Access Compliance Report

Public Rights-of-Way

(Curb Ramps)

Intersection ID: 11109	Main Street: COLEBROOK_RD	Cross Street: MEADOWCLIFF_DR	Location: NE
ADA ID: 3FEBC4514F00	Ramp Type: Perp	Initial Pass/Fail: Fail	Overall Compliance: No
Codes/Mitigation Info/Possible Solution			Severity Score: 10
			Field Measurements/Component Compliance

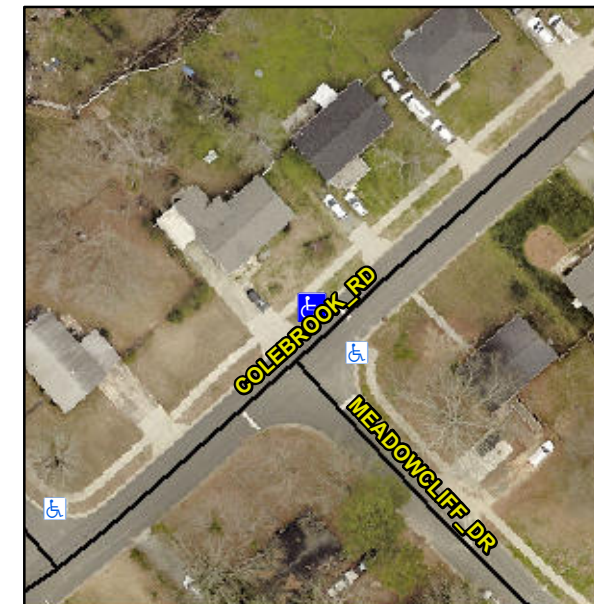
Possible Solutions:

Remove & Replace Entire Ramp.

PROW/ADA:

R304.5.1, R304.5.3

Compliance	Description	Data	Compliance	Description	Data
N/A	Ramp Length (in)	97.0	Yes	Ramp Slope (%)	6.7
No	Ramp Width (in)	47.5	No	Ramp XSlope (%)	2.7
N/A	Flare Type LT	N/A	N/A	Flare Type RT	N/A
N/A	Flare Slope LT (%)	N/A	N/A	Flare Slope RT (%)	N/A
N/A	Flare Traversable LT?	N/A	N/A	Flare Traversable RT?	N/A
N/A	Landing Length (in)	N/A	N/A	DWS Provided?	N/A
N/A	Landing Width (in)	N/A	N/A	DWS Contrast?	N/A
N/A	Landing Slope (%)	N/A	N/A	DWS Length (in)	N/A
N/A	Landing X Slope (%)	N/A	N/A	DWS Full Width?	N/A
N/A	Landing Curb? (Y/N)	N/A	N/A	DWS Offset (in)	N/A
N/A	Shared Landing?	N/A			
N/A	Gutter Ponding?	N/A	N/A	Gutter Slope (%)	N/A
N/A	Gutter Lip Ht (in)	N/A	N/A	Gutter X Slope (%)	N/A
N/A	Painted X Walk1?	No	N/A	Painted X Walk2?	N/A
	X Walk 1 Direction	To SE		X Walk 2 Direction	N/A
N/A	X Walk 1 Width (in)	N/A	N/A	X Walk 2 Width (in)	N/A
	X Walk 1 Slope (%)	1.2		X Walk 2 Slope (%)	N/A
	X Walk 1 X Slope (%)	2.1		X Walk 2 X Slope (%)	N/A
